Re. Reports G21073 (Phase 1) and G21103 (Phase 2) – Proposed Development Land at Dearne Grange Farm, Cumberworth HD8 8YA

We have received some comments from a planning officer regarding the above project/reports. The comments we have received are reproduced in blue and red text below and subsequently answered paragraph by paragraph.

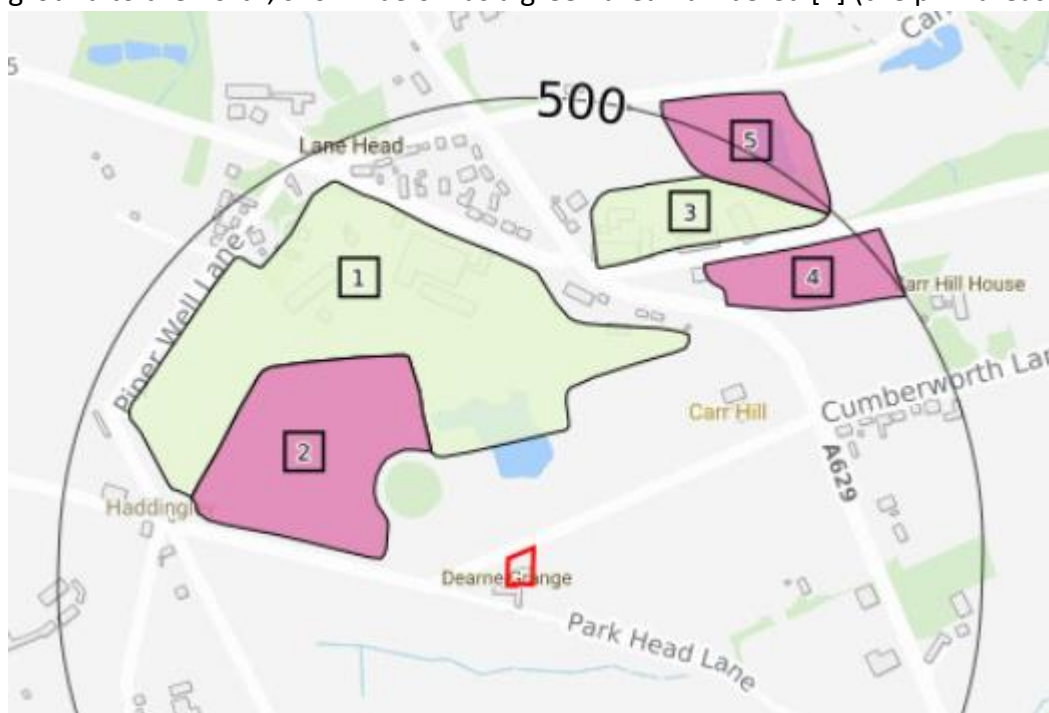
In summary, we generally agree with the report findings and recommend Condition 3 is discharged. However, we would expect that in a site of high sensitivity end-use that is within 250m of a landfill that gas monitoring should be undertaken in line with CIRIA 665 guidance.

The site is not within 250m of a landfill.

Note that materials acquired to compile the Phase 1 Desk Study report reviewed historical landfill records and found limited records approximately 330m-380m to the northeast, but none within 250m.

I assume the reviewing officer is referring to the BGS 1:50,000 mapping which shows an area of infilled ground to the north, shown below as a green area numbered [1] (the pink areas denote worked ground):

Please note that the majority of this area is currently an open quarry and is not infilled ground. However, the historical map record does perhaps suggest that there may be some artificial ground below the commercial structures to the east of the number [1] on the image above, see extracts on the following page.
